TANDBERG

Gatekeeper

Software Release Notes

Software Version N6

Command Line Help

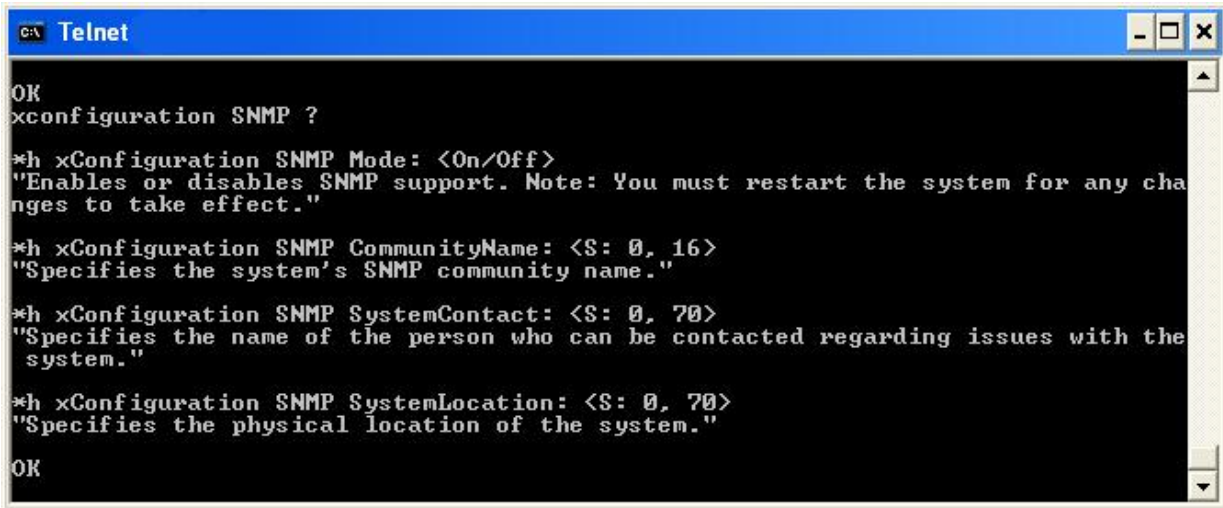
Descriptions have been added to the CLI of the TANDBERG Gatekeeper. When a question mark (?) is entered after an 'xcommand' or 'xconfiguration' parameter, a brief explanation of that command or parameter is displayed. In the example below the question mark '?' was entered after the 'xconfiguration SNMP' parameter which displayed a brief description of the available parameters [Ref. 17110].

Command Line Completion

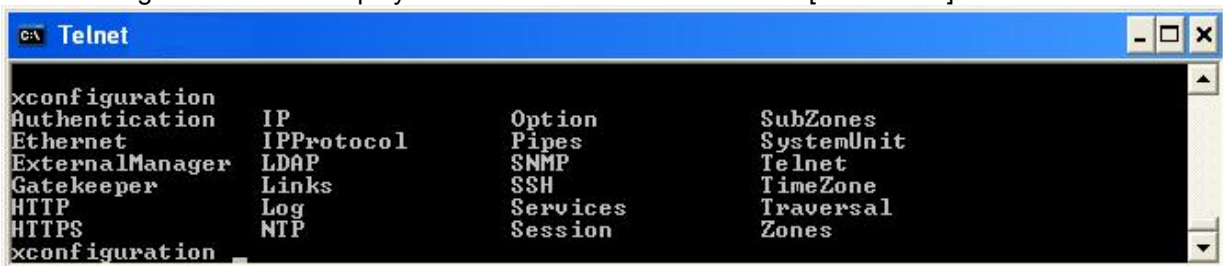
When typing an 'xcommand' or 'xconfiguration' parameter, the 'TAB' key can now be used to complete the command word or offer possible completion words. If the 'TAB' key is pressed twice it will display a list of possible commands that are available. In the example below the 'TAB' key was pressed twice after 'xconfiguration' which displayed the list of available commands [Ref. 46877].
